CERTIFICATE OF APPROPRIATENESS

Property: 1802 North Blvd, Lot 6 &7, Block 6, Ormond Place Subdivision in Boulevard Oaks Historic District. Two-Story, 3,959 sq ft (18%) single family residence situated on a **21,000** square foot (150 'x 140') corner lot.

Proposal: Alteration – Addition

EAST ELEVATION – FACING STREET
EXISTING

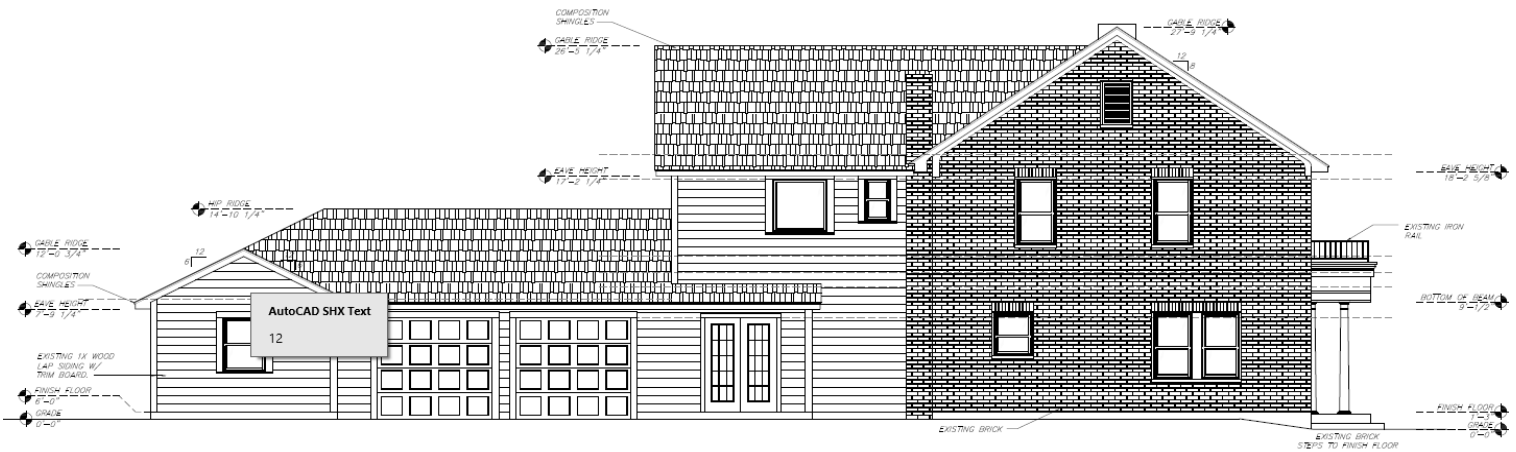
- Demolish part of c.1980s addition (including-non-historic windows)
- Two historic windows will be infilled with brick at rear elevation visible from Woodhead

Our family lives in one of the houses backing up to the historic house at 1802 North Boulevard. We have concerns about the additions to the house since they will significantly change the face to the street and are not to scale nor of the era of the historical district. We were not able to attend the first meeting since we were out of the country and the signs giving notice hadn't been posted 10-days in advance. The Project Description on the historical tracker only mentions the 1872 square feet of "proposed living space" and fails to mention the oversized 3-car garage and unfinished room above it. It wasn't until after calling Roman that the floorplans were added that truly show the large scale of the addition. This 3-car garage addition width is unproportionate for the structure and will nearly double the face of the house to the street. While this area may not have the concrete rules like the Heights that limit the width of the side addition to half of the setback from the side wall, the width of the 3-car garage structure should still be in violation of the following committee rules:

garages have a curving driveway that makes the garage mostly hidden behind the original house. The addition behind the original structure seems reasonable to add a second story since it is not visible from North Blvd as long as it does not build in the easement. However, the 3-car garage and the scale of the side addition is a travesty since it is too large compared to the original structure. This house is actually a charming house and the massive addition is not in the interest of the neighborhood. It is purely in the interest of the seller who wants to maximize their profit. As a result of the rules that are violated above, we suggest the committee rejects the addition since it is too large for the house and does not preserve the historical character of this district.

<i>Windows removed at rear are not considered as significant as those on the front or side elevations.</i> | |

Additionally, the proposed addition violates NONE of the rules that Mr. Adib claims they would:

Mr. Adib seems to take umbrage at the size of the garage addition. First of all, the view of the garage will be covered up by the line of Japanese Yews that are already there.

As to the question of massing, the size of the current house is so far below the historical standard for the neighborhood that even with the addition it will *still* have the *least* mass per square foot of land on the block. There are nine other "historic" houses on the block. Their collective square footage of living space is 38,283 square feet. Their collective land is 102,260 square feet. So, the percentage for the block of house to land is 37.4%. The current percentage for 1802 North Blvd is 16% (3,361/21,000). So, if the **historic standard** for the block is 37.4%, any addition to 1802 North *only brings it closer to that standard*, not further.
